PV Climate

validation report

Restoration of barren uplands of vulnerable communities in West Bengal and Jharkhand

Version 2.1

Figure 5: Location map showing Project area and Project polygons - independent assessment of the intervention areas assessed by the VVB

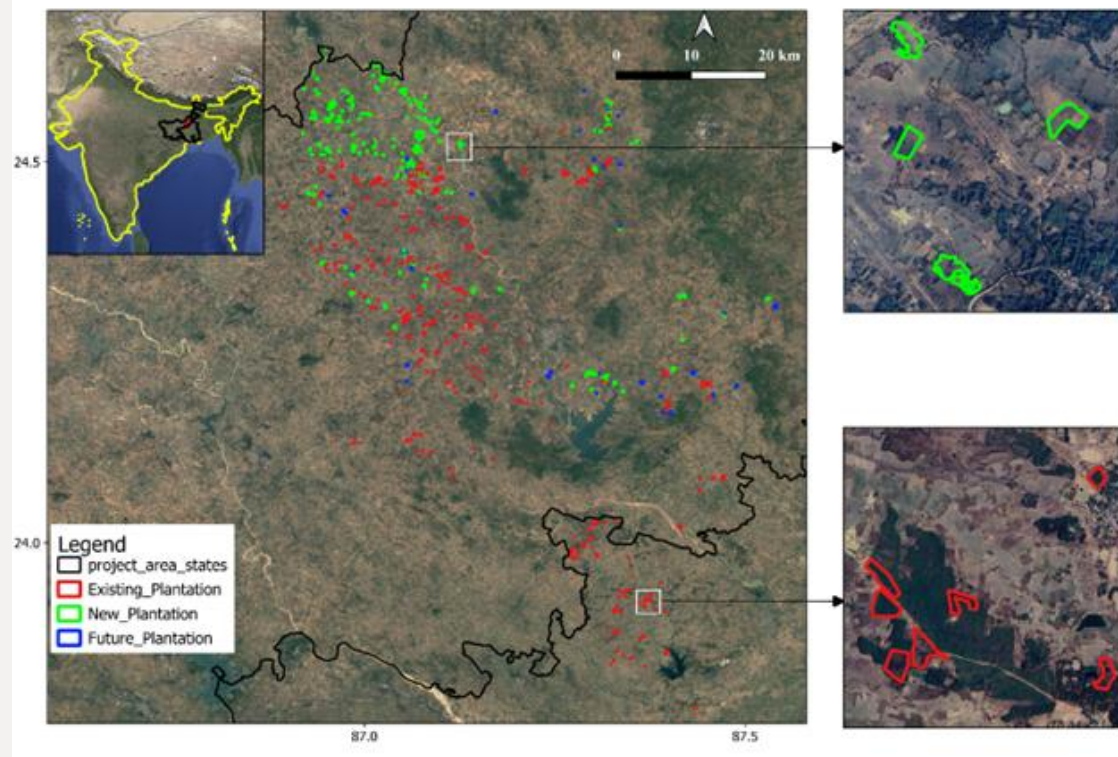
All the issues identified, described as findings in Annex 2 (see CAR 03 and NIR 01), have been clarified and closed based on the new evidence provided: the last version of the PDD /8/ and the last version of the GIS files with the currently onboarded farmers. The validation team concluded that the project boundaries comply with PV Climate requirements.

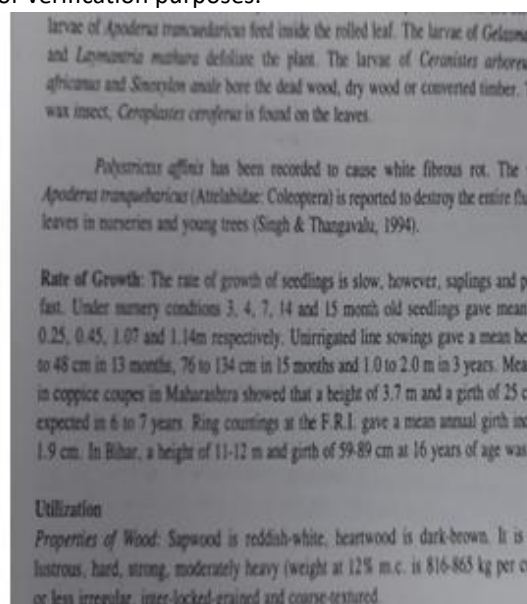
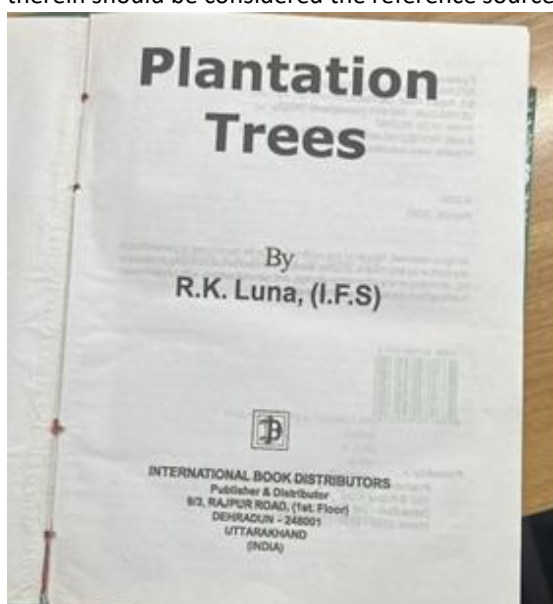
Expected GHG benefit after 20 %Buffer (0% Mortality)	Expected GHG benefit after 20 %Buffer (20% Mortality)	Expected GHG benefit after 20 %Buffer (40% Mortality)	Mortality	15%	8%	5%	2%			Year 0	Year 1	Year 2	Year 3	Year 4
Expected GHG benefit after 20 %Buffer (0% Mortality)	Expected GHG benefit after 20 %Buffer (20% Mortality)	Expected GHG benefit after 20 %Buffer (40% Mortality)																	
Mortality	15%	8%	5%	2%															
	Year 0	Year 1	Year 2	Year 3	Year 4														
5. Source for terminalia growth is not accessible 6. From the sheet it is not clear of the gap filling is being done or not. 7. PC to recheck the estimates in average 30 year sheet as the annual carbon numbers seems incorrect. This will further change once the LTA estimates are done as per the methodology 8. A further mortality has been considered in the final ERR numbers, basis for same is not clear. 9. Why in the ERR “inputs” subsheet Assumed Average Plot Size per HA (Community) is included? 10. What is the relevance of “cost stack” subsheet in the ERR?																			
Project Coordinator response				Date: 14/02/2025

1. PC would like to clarify that ERR calculated from the start year of the project (2020) for the whole crediting period. The information is incorporated into the ERR sheet and the PDD.

2. The growth and biomass reference for *Acacia auriculiformis* has been revised and is now sourced from a study conducted in Jharkhand, ensuring consistency with the ecological and climatic conditions of the project area. The corresponding reference link has also been updated accordingly in the ERR Sheet. In addition, the volume equation applied is taken from the India State of Forest Report (ISFR), 2021 and is specific to West Bengal, making it realistic for the project region.

4. The PC would like to clarify that the mortality assumptions previously referenced were considered solely for internal assessment purposes and were not intended for application in the final emission reduction calculations. These assumptions have now been removed. The revised ERR sheet, reflecting the corrected calculations, has been uploaded in Exhibit 3 of the evidence folder for review.
